SERVICE BULLETIN NUMBER 517

DET-1620 for use with **CPU-95EVS**

10/14/14

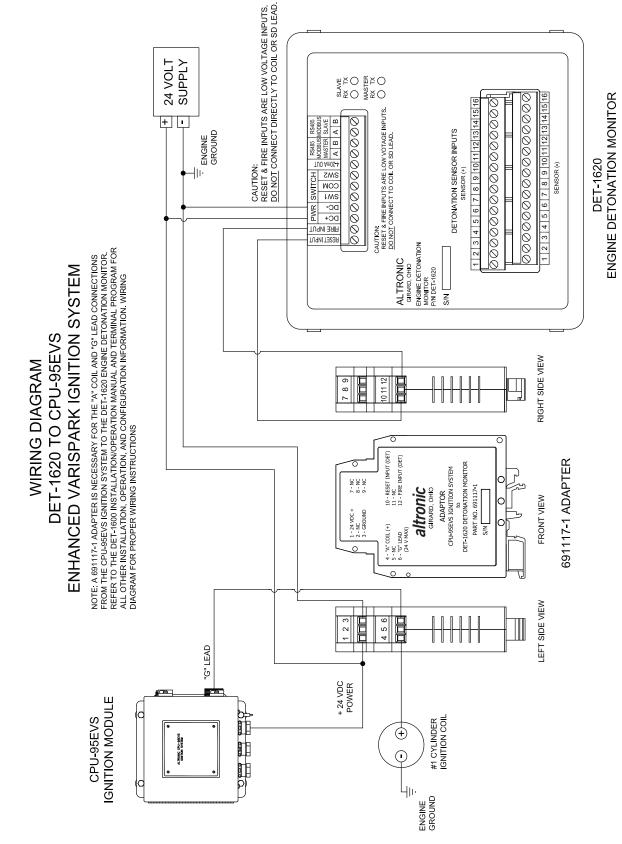
Detonation Sensing applications that employ the CPU-95EVS will require the specification of the DET-1620 along with an adapter (691117-1) to condition the "A" coil connection along with the "G" lead connection. This module has a current user price of \$152.00 and is available for order.

The DET-1600 cannot be used with the "EVS" version of the CPU-95.
